RE: 2009 New Mexico Earthen Building Materials Code

This letter is to encourage the adoption of the content of the 2009 New Mexico Earthen Building Materials Code, with specific guidance and recommendations for some items following, as an amendment to Ordinance 2019-10 for Coconino County.

##### **F. Openings**

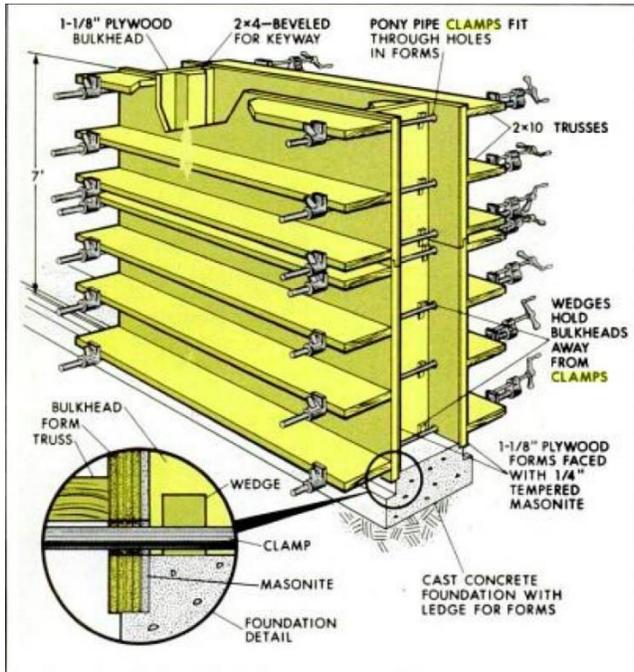
The inclusion of these requirements is important for the structural integrity of the corners of rammed earth buildings; we recommend it be included for adobe and compressed earth block building corners as well.
